George Vanderheyden
Vice President
Calvert Cliffs Nuclear Power Plant
Constellation Generation Group, LLC

SUBJECT: Calvert Cliffs Nuclear Power Plant
Unit No. 1; Docket No. 50-317
Supplemental Data for Request for Relaxation from Interim Inspection Requirements for Reactor Pressure Vessel Head (TAC No. MC1921)

RESPONSE TO REQUESTS FOR ADDITIONAL INFORMATION

Figure 1: Illustration of Stress Analysis Mesh Indexed to Node 81401

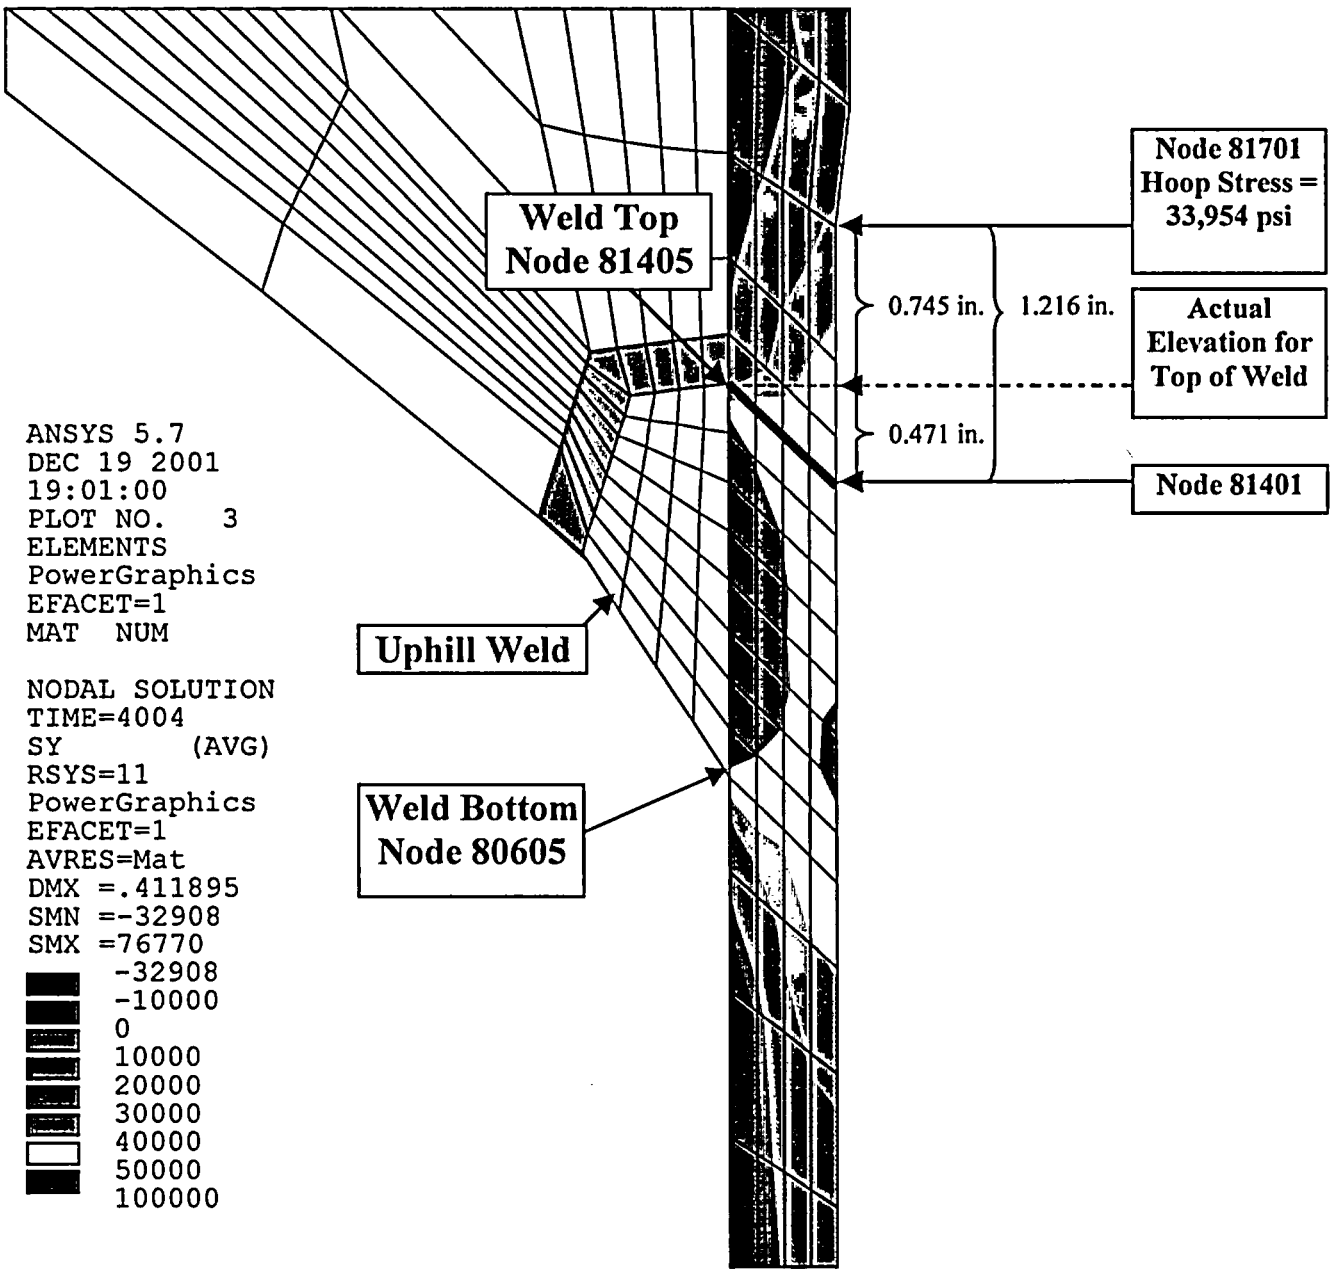
In CCNPP relaxation request dated January 30, 2004, it was stated that the most limiting inspection area during the 2003 inspection was on the 42.5 degree nozzle and the reported stress values were based on finite element analysis. The licensee stated that the new stress values reported for the Spring 2004 outage are lower than those originally provided. The licensee stated that the new values were based on absolute elevation values which shows that the stresses computed by the FEA model were lower than the values reported in the 2003 inspection submittal.

Explain in detail how the absolute elevations of the top and bottom of the weld were obtained.

Provide an example using this methodology. For example, for node 81701 at a 43 degree angle, the distance above the J-groove weld was 1.216 inches and the Hoop Stress calculated in the FEA was 33954 psi.

With the updated post-processing method, a nozzle at 43 degrees with a distance of 1.185 inches above the weld has a Hoop Stress calculated at 16.2 ksi. CCNPP needs to justify this huge discrepancy in stress values.

nodes at the nozzle outside diameter (OD)/weld interface. The bottom of the weld is the lowest node along this interface and the top of the weld is the highest node along this interface. Please refer to Figure 1 where the top and the bottom of the weld for the uphill weld are identified for the 43degree angle model.

The discrepancy in stress values between the 2003 relaxation request and the 2004 relaxation request is due to a conservative simplification of the model geometry used in 2003 to calculate stresses above the top of the weld at the uphill side. Figure 1 is a plot of the operating hoop stresses at the uphill side of the 43 degree nozzle. The nodes at the top and bottom of the weld are identified, as are nodes of interest on the inside diameter (ID) side of the nozzle.

As shown in the table, nodes 81405 (on the OD) and 81401 (on the ID) were both assumed to be at the same absolute elevation (shown in bold). In fact, node 81405 is at the elevation of the weld root, but node 81401 is below the elevation of the weld root as shown in Figure 1 (by the bold line). In 2003 we reported the stresses on the nozzle ID surface at various distances with respect to 81401 instead of with respect to 81405. The assumption that 81401 and 81405 were at the same elevation simplified the determination of stresses, but provided values that were conservatively high.

The stress at node 81701, which is 1.216 inches above node 81401, is 33,954 psi. The stress at this node in 2004 is that same as it was in 2003. As shown in Figure 1, this stress value agrees with the stress contours of the hoop stress plot.

In 2004, it was decided to report ID stresses in reference to the location of the top of the weld. As shown in Figure 1, node 81701 is actually only 0.745 inches above the top of the J-groove weld.
